Landmark Commission

AGENDA

APPLICATION FOR A CERTIFICATE OF APPROPRIATENESS FOR EXTERIOR ALTERATIONS TO 142 COLUMBUS AVE.

Reference Number: PLC 20-0014

FRONT ELEVATION
SCALE: 1/4" = 1'-0"

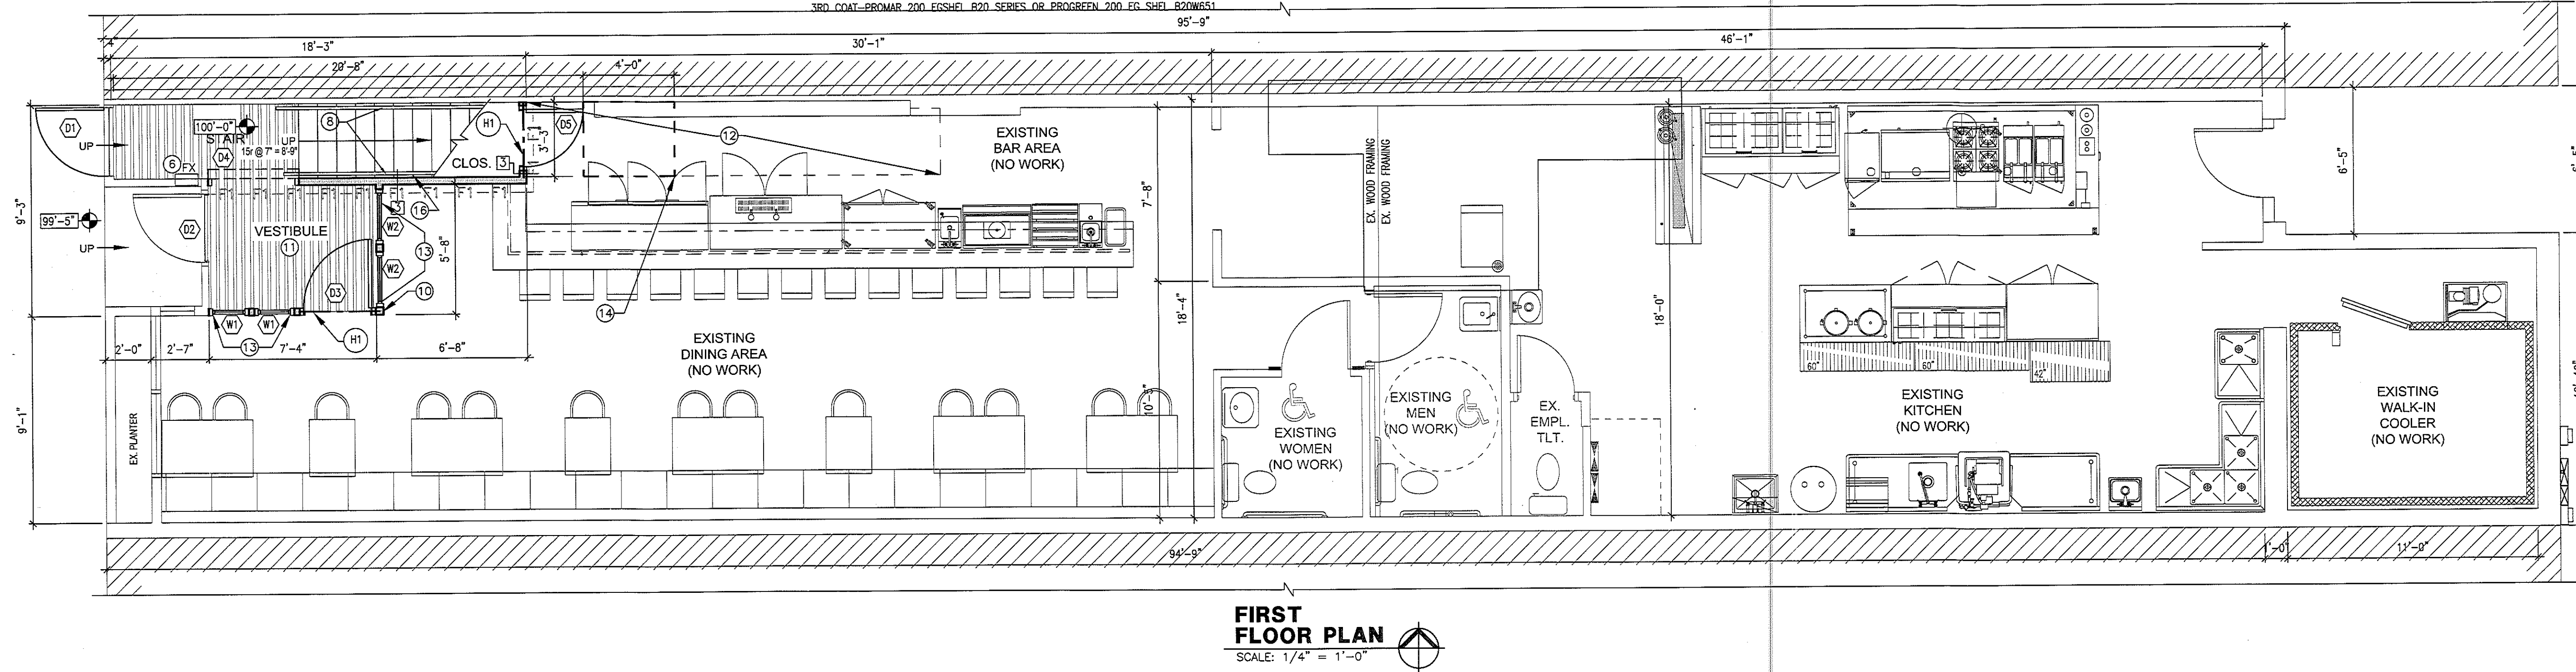
This application is requesting to add a singular sliding window that would replace the three smaller windows on the second floor. The window would be made of aluminum and black in color. An example photo of the folding window system has been included with the application packet.

The façade of the building has been so heavily altered over the years that the first and second stories retain little to no original historic features. The window openings were significantly reduced in size and are much smaller than the original windows in the building. Replacing the three windows with a singular sliding window would not be detrimental to the historic character of the building. Staff recommends approval of the certificate of appropriateness.

- NEW FOLDING WINDOW UNIT w/RETRACTABLE SCREEN PER WINDOW SCHEDULE; THIS REPLACES (3) DBL. HUNG WINDOWS WITHIN EXISTING EIFS SYSTEM.
- REPLACE EXIST'G ENTRY DOOR w/NEW PER DOOR SCHEDULE
